**RE: *Meliadine Mine 2024 Annual Report for Water Licence 2AM-MEL1631***

Agnico Eagle Mines Limited (Agnico Eagle) thanks the Nunavut Water Board (NWB) for the opportunity to address comments received for Agnico Eagle's Meliadine Gold Mine 2023 Annual Report.

250703 2AM-MEL1631 Meliadine Gold Mine 2024 Annual Report KIA Comments-IMLE  
250707 2AM-MEL1631 Meliadine Gold Mine 2024 Annual Report DFO Comments-IMLE  
250708 2AM-MEL1631 Meliadine Gold Mine 2024 Annual Report ECCC Comments-IMLE  
250718 2AM-MEL1631 Meliadine Gold Mine 2024 Annual Report CIRNA Comments-IMLE

**Figure 1. Temporal changes in Catch Per Unit Effort (CPUE) for Threespine Stickleback (THST) among the three study areas in Meliadine Lake.**

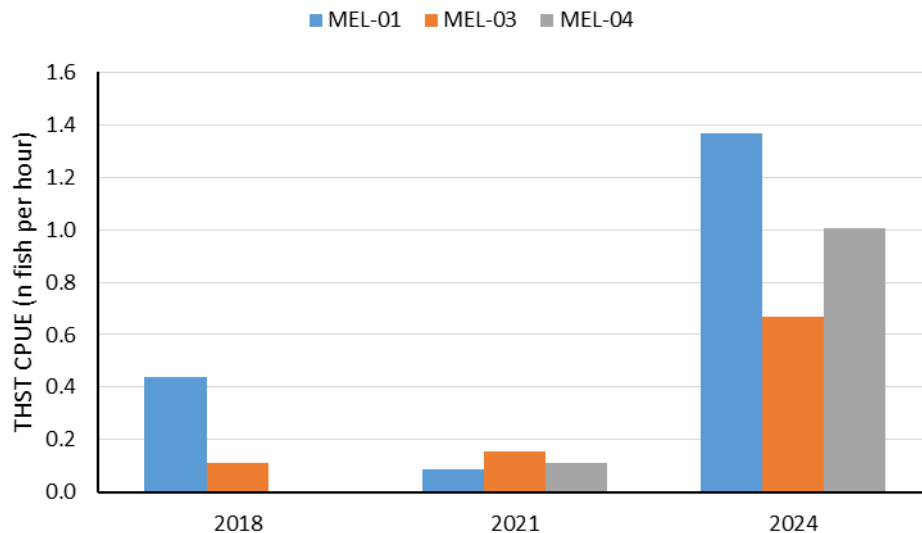
Proponent to provide each years CPUE data in the annual report so that comparison can be made between years.

Results of CPUE for Threespine Stickleback from the 2018, 2021, and 2024 monitoring years are presented in Table 1 and illustrated in Figure 1.

CPUE results do not show a consistent increasing or decreasing trend across the three sampling years. At MEL-01 specifically, CPUE declined from 2018 to 2021, then increased from 2021 to 2024.

**Figure 3. Comparison of Threespine Stickleback findings between Cycle 2 (2021) and Cycle 3 (2024).**

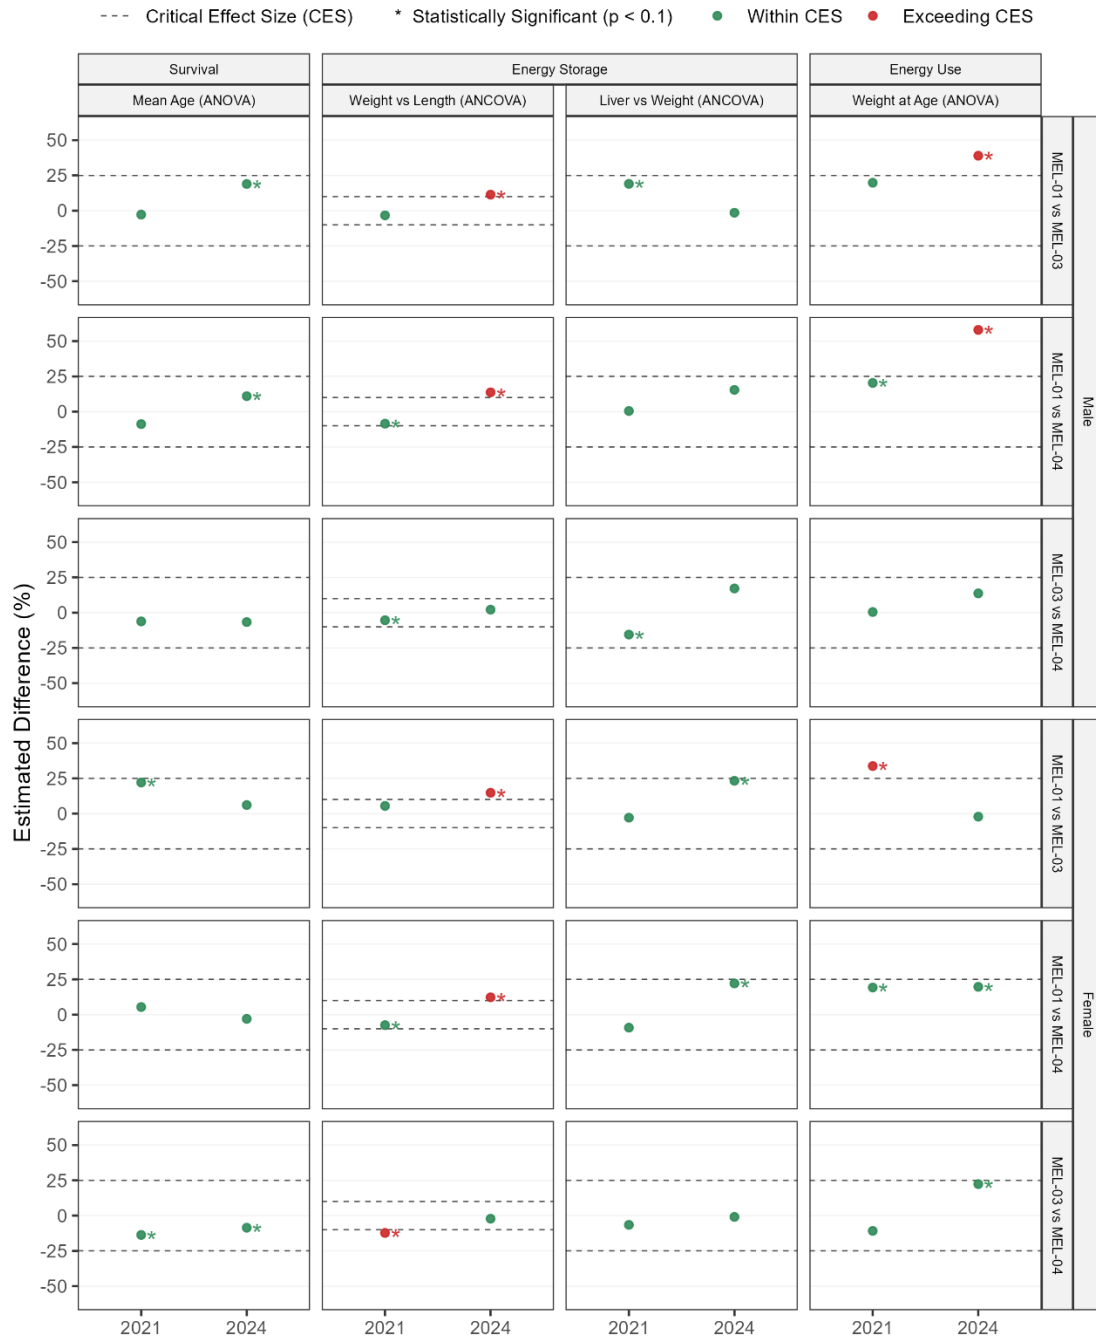
- describe and implement a response to reaching the Low Action Level for fish health from nutrient enrichment in Meliadine Lake; and
- develop Moderate Action Level for fish health in Meliadine Lake.

As per answers to 2024 NIRB Annual Report Comments, ECCC’s interpretation of the Low Action Level exceedance for nutrient enrichment aligns with the criteria outlined in Table 6-3 of the AEMP Design (Azimuth 2025). However, the table does not explicitly reference the requirements under the Metal and Diamond Mining Effluent Regulations (MDMER). This was an oversight in the most recent update to the AEMP Design Plan. According to the Environmental Effects Monitoring (EEM) Technical Guidance Document, to confirm that observed effects are mine-related and not artifacts or the result of confounding factors, biological monitoring studies must be repeated in a subsequent three-year phase. If a similar type of effect—defined as the same endpoint, showing the same direction of change from zero relative to reference levels—is observed in two consecutive phases, the effect is considered confirmed.

The results of the Cycle 2 (2021) and Cycle 3 (2024) Threespine Stickleback studies indicate that no endpoints exceeded the Critical Effect Size (CES) in two consecutive cycles (Figure 3). Therefore, in alignment with MDMER and the EEM framework, the primary course of action is to confirm the 2024 results through a follow-up study, which is scheduled for the summer of 2027.

**Figure 4. Arsenic concentrations in the sediment core collected from Lake B7 on August 21, 2024.**

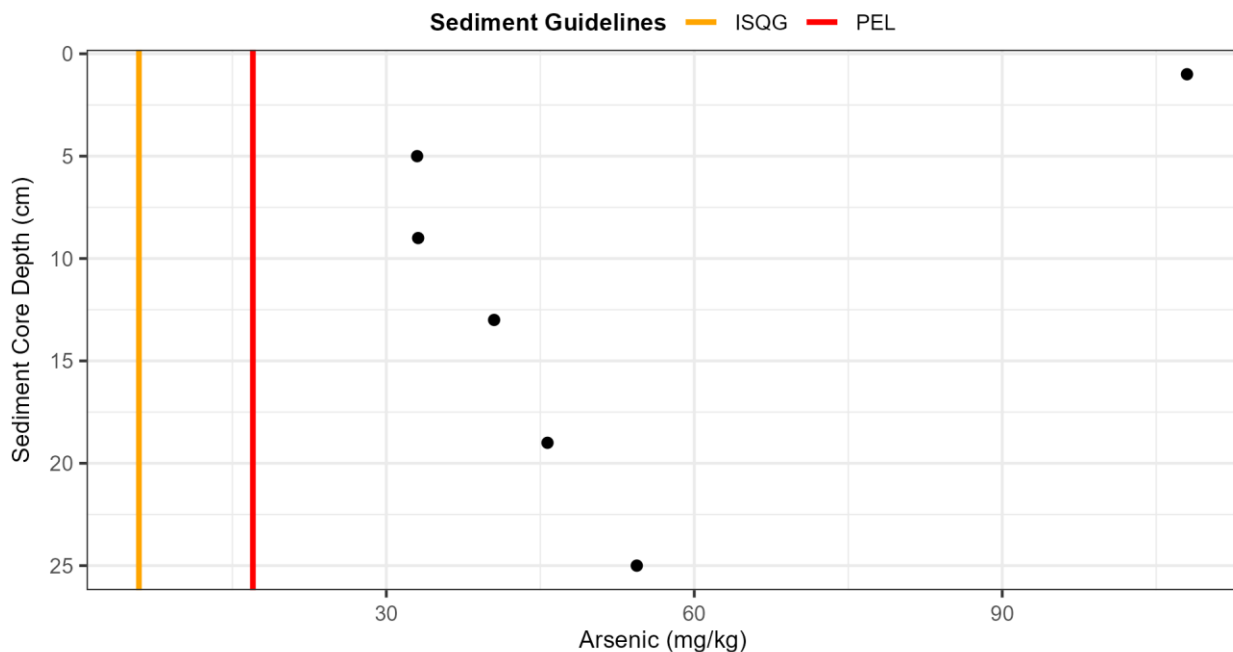
AEM also states that “overall, current arsenic concentrations in Lake B7 pose a low risk of adverse effects to fish and other aquatic life”. CIRNAC finds this statement questionable given the reported exceedances of the SSWQO.

- a. Carry out a comprehensive investigation into the potential source of arsenic in Lake B7.
- b. Based on investigation results, develop mitigation plans for the operational mine life.
- c. Indicate why the 2024 exceedances of the arsenic SSWQO in Lake B7 are not classified as a non-compliance event,
- d. Carry out a risk assessment of Lake B7 to assess post-closure risks and potential remedial requirements once the water body is reconnected to the surface water environment after being used as a saline pond (SP6) during operations.

On August 21, 2024, Azimuth collected a sediment core from the depositional area of Lake B7 to delineate the vertical concentration profile of metals of interest in the sediment. This reconnaissance-level sampling program was designed to provide preliminary insight into whether recent dust deposition is evident in the sediment record. Evidence of dust deposition would be

As shown in the figure below, arsenic concentrations in the top 0–2 cm of the sediment profile were 108 mg/kg, compared to 30–55 mg/kg in deeper core intervals. While the core chemistry results alone do not definitively confirm dust as the source, the approximately threefold increase between the 0–2 cm and 4–6 cm horizons suggest recent loadings consistent with a dust deposition.
